P&WC S.B. No. 41057R6

TURBOSHAFT ENGINE  
SHROUD HOUSING, COMPRESSOR TURBINE - REPLACEMENT/MODIFICATION OF

PT6C-67C

Sep 21/2011  
Revision No. 6: Feb 24/2021

Power Turbine Housing Modification  
Figure 1

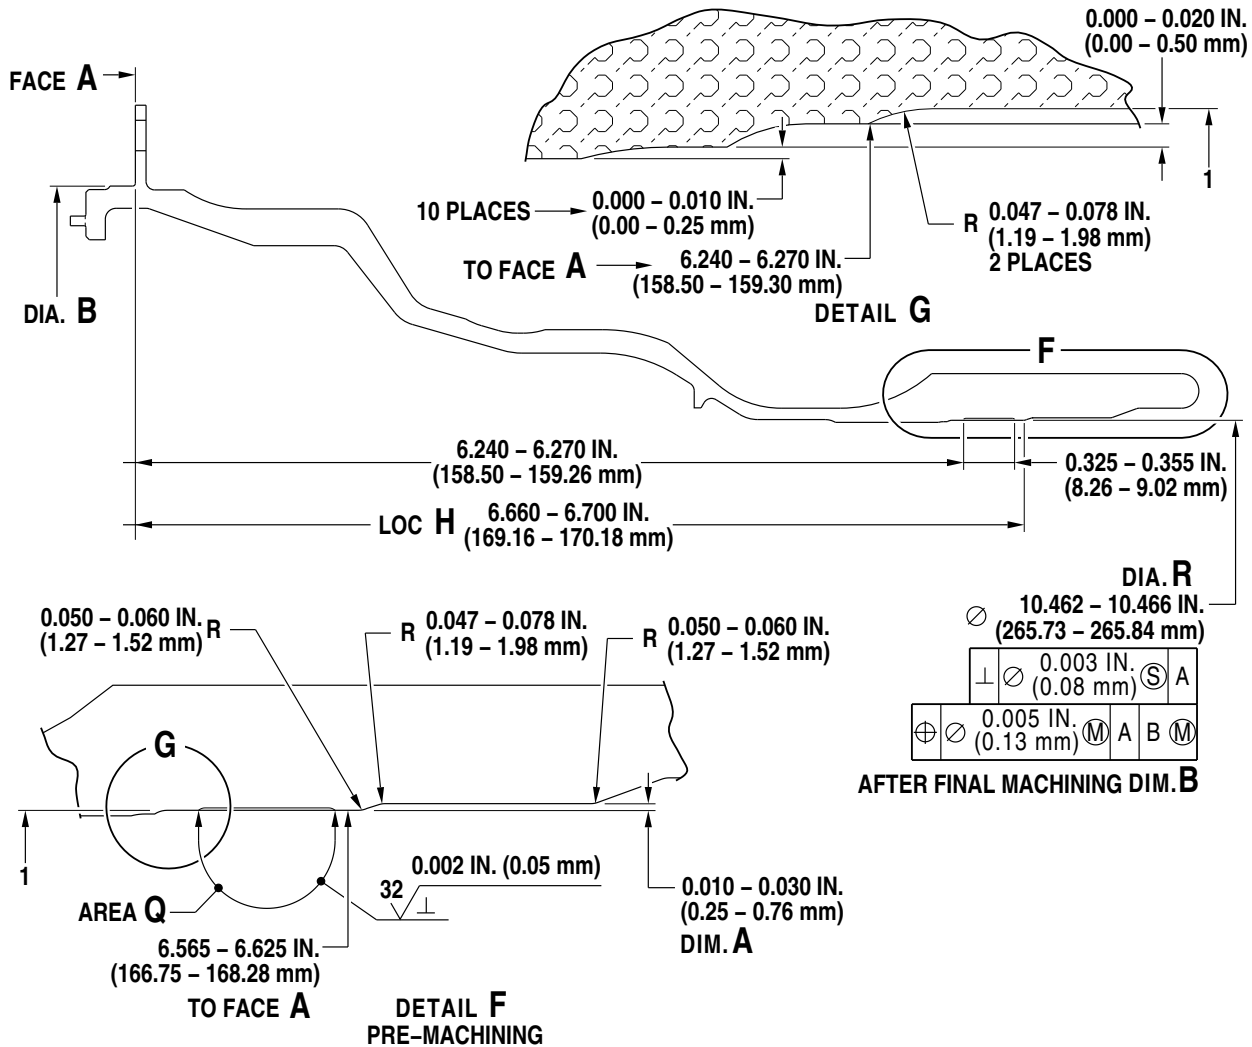
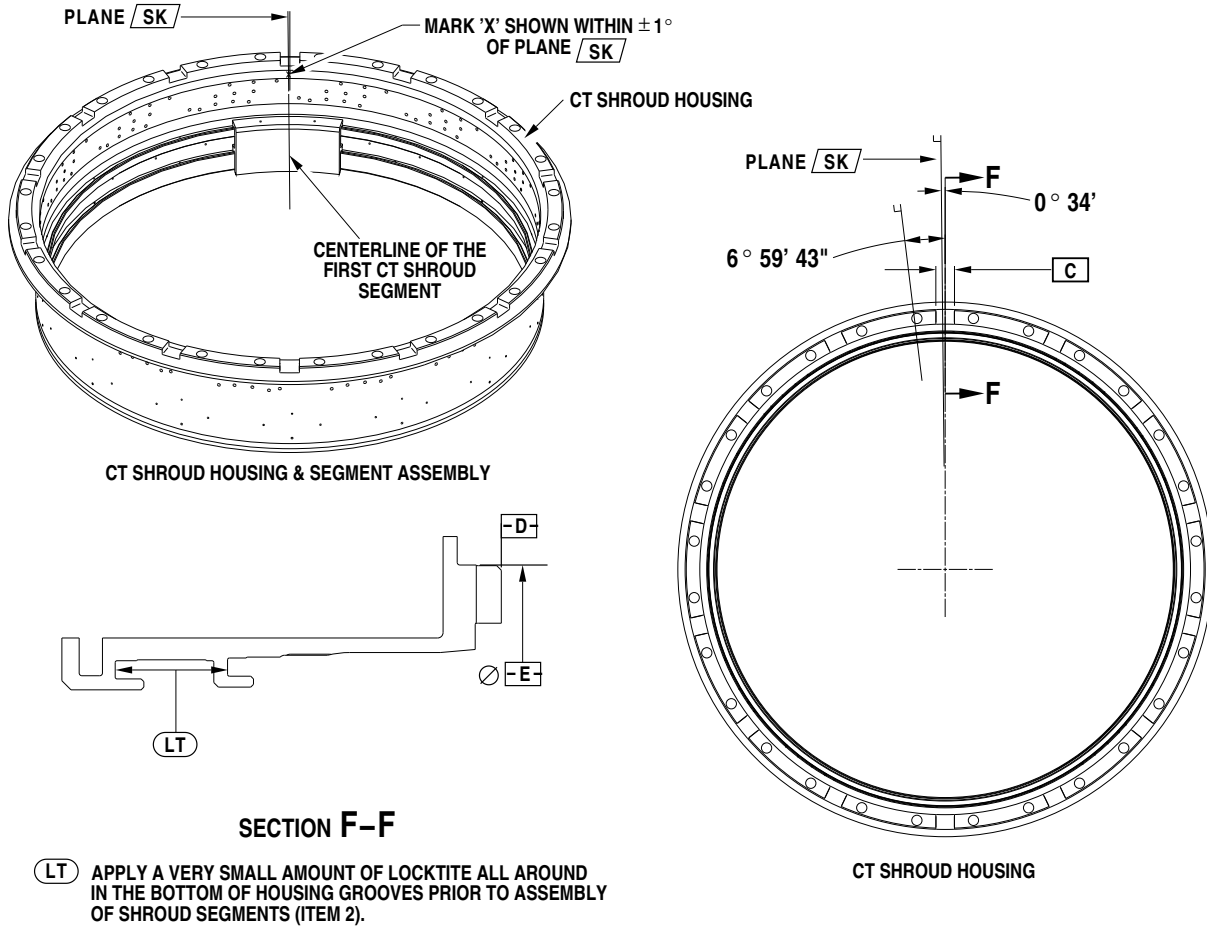
- change the compliance code from CC5 to CC4 in Para. 1.E., Planning Information.
- modify Fig. 1 to read Dia B in lieu of Face B.
- update the pricing to the current year.

- B. Verify if Dim at location H of power turbine housing assembly P/N 3059005-01 allows for rework of the part:
- (1) If dimension at location H is greater or equal to 6.660 in. (169.164 mm) - proceed with rework of the part, otherwise replace the existing power turbine housing assembly with a new power turbine housing assembly

- C. The serviceable power turbine stator housing P/N 3059005-01 may be reworked and re-identified as follows (Ref. Fig. 1 and CIR 72-53-50):
- (1) Machine 0.010 to 0.030 in. (0.25 - 0.76 mm) Dia. to remove existing plasma coating on the old sealing diameter location (Ref. Detail F, Dim. A).

- (2) Machine Area Q and adjacent surface (Ref. Detail F and G).

- (3) Fluorescent penetrant inspect reworked area per SPOP 62.
- (4) Prepare surface of Area Q for plasma coating and mask surrounding area.
- (5) Thermal spray enclosed Area Q, (0.005 to 0.008 in. (0.13-0.20 mm) thick.
  - (a) Coat Area Q, with powder (PWC05-012), (Ref. P&WC Overhaul Standard Practices Manual, Chapter 70-46).
- (6) Final machine to dimension shown (Ref. Dim. B).

NOTE: Final plasma thickness after machining must be 0.005 to 0.008 in. (0.13-0.20 mm).

Compressor Turbine Shroud Housing Assembly  
Figure 2 (Sheet 1 of 3)

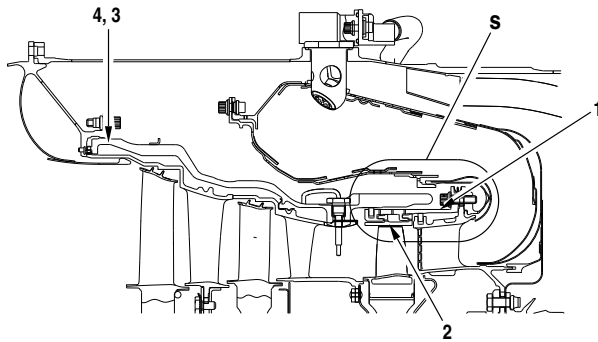
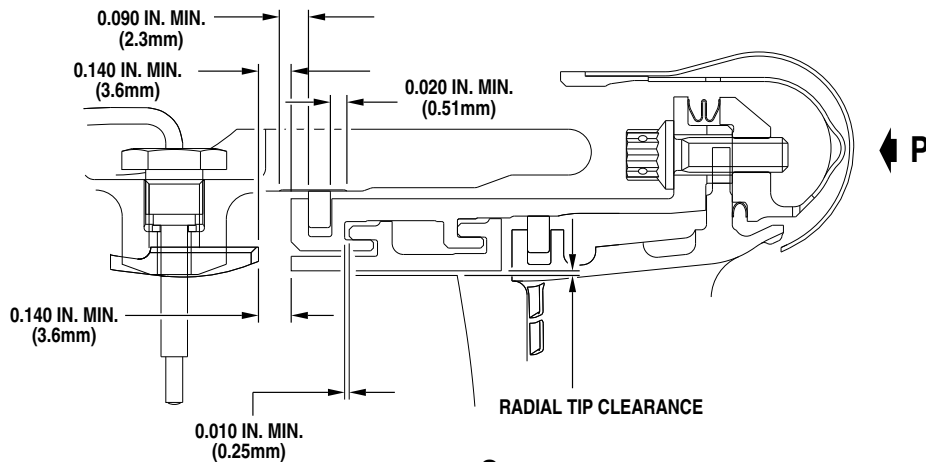
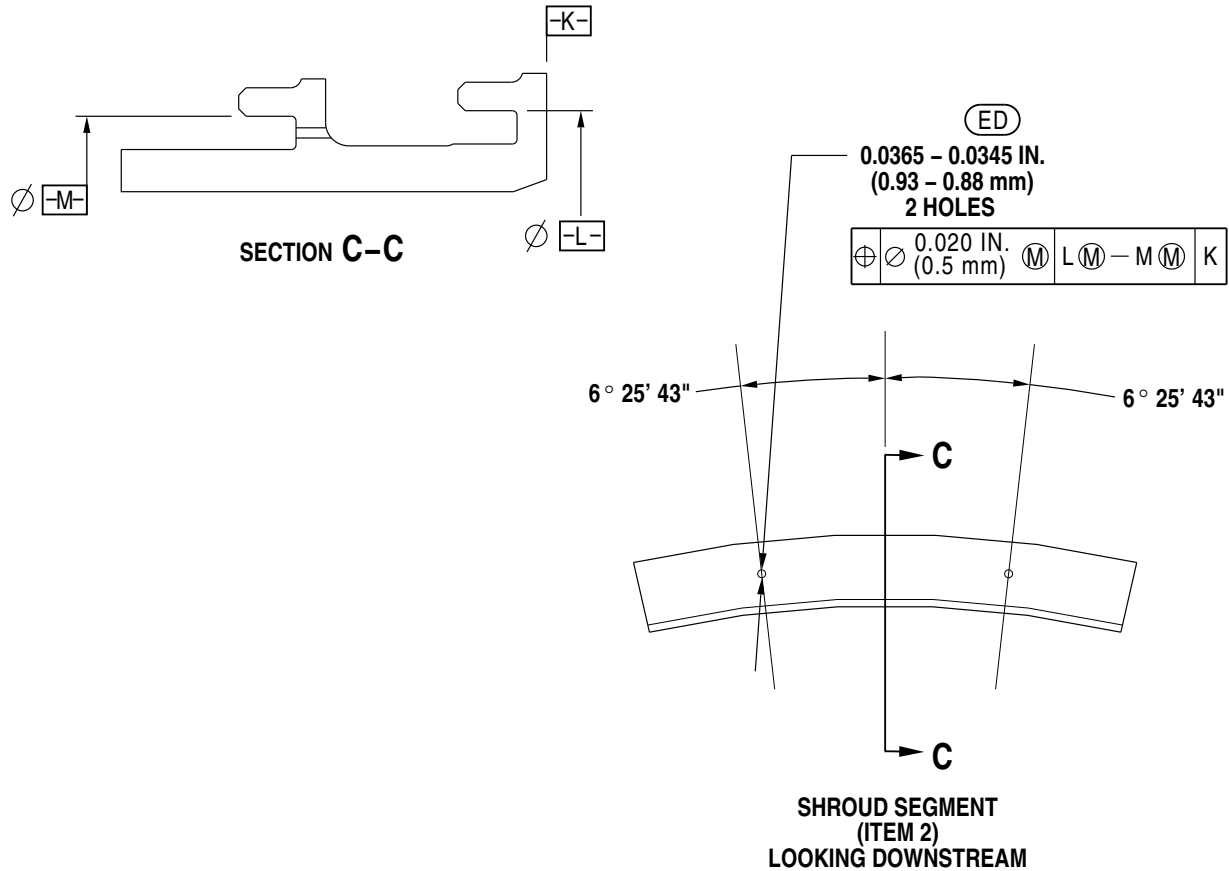
- (1) Apply a small amount of adhesive/sealant (PWC09-002) in the bottom of both housing grooves as shown (Ref. Fig. 2, Sheet 1, Detail F-F).
  - (2) Install the shroud housing P/N 3072898-01 in the base (PWC71508).

- (4) Check clearance (Ref. Table 3, Fit No. 907 and Ref. Fig. 2) is maintained between shroud housing and shroud segments.
  - (5) Install remaining 13 segments one at the time. Maintain required gap between segments (Ref. Table 3, Fit No. 910 and Ref. Fig.2, Sheet 2, View P). Use shim stock to facilitate gap equalization between segments.

Special Assembly Requirements  
Figure 3

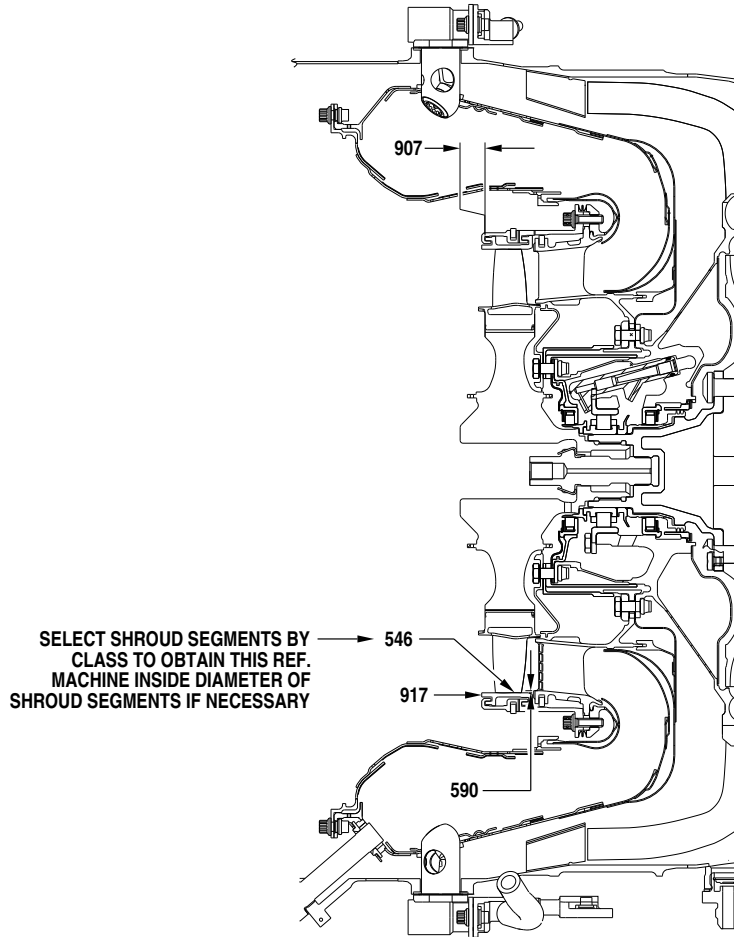
D. Refer to Table 3 for Special Assembly Requirements and Ref. Fig. 3.

REF. NO.	IFR	Nomenclature	Limits		
			Min.	Max.	Replace
<b>Post-SB41057</b>					
907		Axial gap between housing, Compressor Turbine Shroud and Shroud Segment.	0.0200 L (0.508)L	0.0300 L (0.762)L	
<b>Post-SB41057</b>					
910		Gap between each shroud segment, applicable when the shroud segments are loaded inward	0.0105 (0.267)	0.0145 (0.368)	
<b>Post-SB41057</b>					
917		Center line of one shroud-segment must be lined up with "x" mark on Housing, Compressor Turbine Shroud within $\pm 0.100$ .
